**JOINT REGIONAL PLANNING PANEL
(Sydney West Region)**

JRPP No.	2014SYW166
DA Number	DA/799/2014
Local Government Area	Parramatta City Council
Proposed Development	Demolition, tree removal and construction of an office building, Chancery building and a Parish Hall and associated basement parking on Lot 1 DP 1034092 and construction of a part 5 part 6 storey residential flat building, comprising 77 units with two levels of basement parking on Lot 5 DP 1182647.
Street Address	No.1 Marist Place & No.26 O Connell Street, PARRAMATTA
Applicant/Owner	The Catholic Diocese of Parramatta/ Trustees Roman Catholic Church
Number of Submissions	No submissions
Regional Development Criteria (Schedule 4A of the Act)	Pursuant to Clause 3 of Schedule 4A of the Environmental Planning and Assessment Act 1979, the development has a capital investment value of more than \$20 million
List of All Relevant s79C(1)(a) Matters	State Environmental Planning Policy No. 65, State Environmental Planning Policy No. 55, State Environmental Planning Policy (Infrastructure) 2007, Sydney Regional Environmental Plan (Sydney Harbour Catchment) 2005, Parramatta Local Environment Plan 2011.Parramatta Development Control P

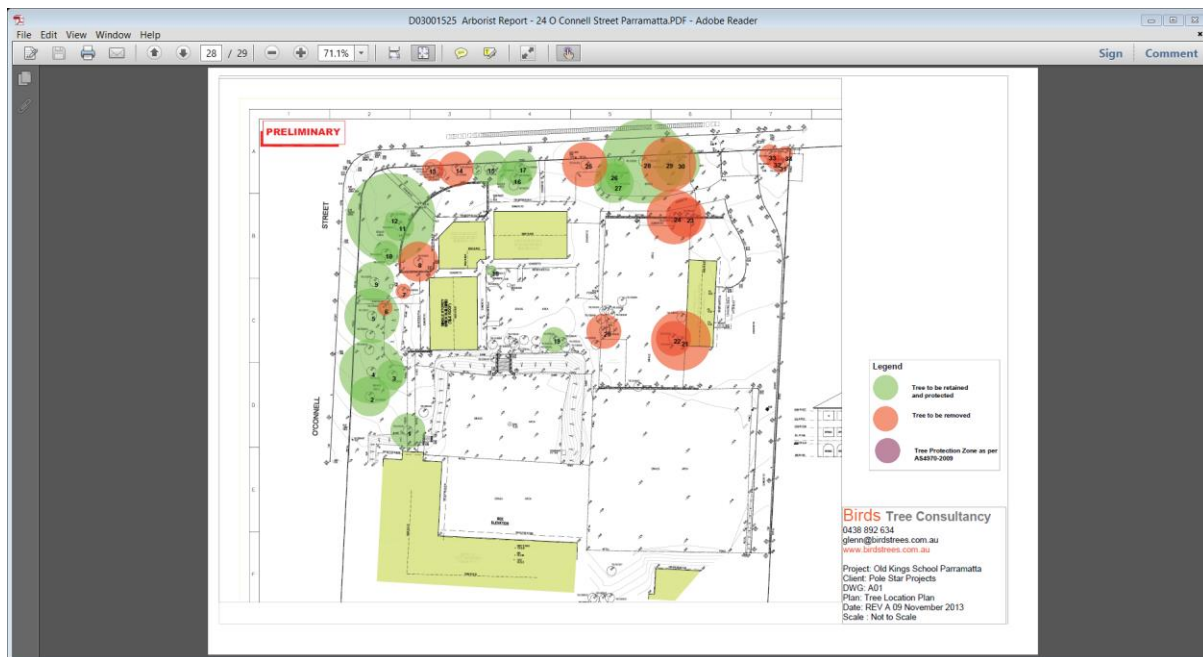
This image indicates the trees to be retained.

This image indicates the likely extent of the area requiring decontamination.

The above image, taken from D03001525 Arborist Report - 24 O Connell Street Parramatta 10/12/2013 at 9:40 AM, shows the arborist’s previous report for DA/817/2013, which indicates that there would likely be sufficient room to safely remove the arsenic contaminated soil without impacting on any of the trees identified to be retained.
